**URGENT Field Safety Notice**  
**ProxiDiagnost N90 1.1 and ProxiDiagnost Upgrade**

Software Defects causing imaging issues during Radiography and Fluoroscopy examination

05-December-2023

**Figure 2. Export only “not flagged” images**

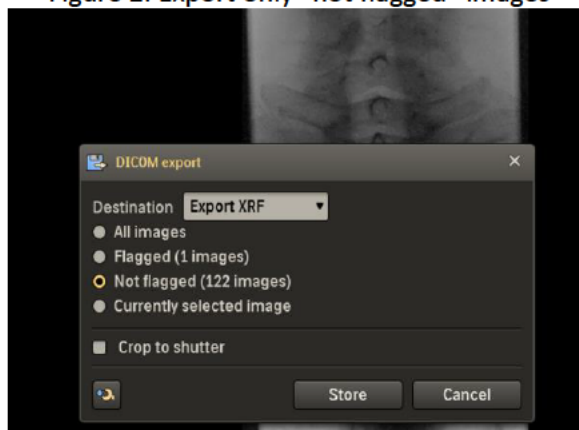
**Issue 1: Mixed Images:** Philips has identified that the Radio Fluoroscopy (RF) viewer may also display a previous patient's radiography (RAD) images when starting the next patient scan while the previous patient image export is still processing. If the issue occurs, there is a potential for incorrect patient data to be displayed in the image.

- To avoid previous patient data from being represented as current patient data, ensure all images have been exported from the previous RAD exam before starting a new examination.
- Correct images will be square shape and wrong images can be recognized by a different patient anatomy and rectangular shape. If you identify a wrong image, flag the incorrect images and only export “not flagged” images for the current examination to PACS (See figure 2 below).

A Field Service Engineer (FSE) will contact you to schedule a time to visit your site and install the software upgrade to resolve the issues (Reference FCO70600110). Philips plans to start implementing the solution in Q2 2024.
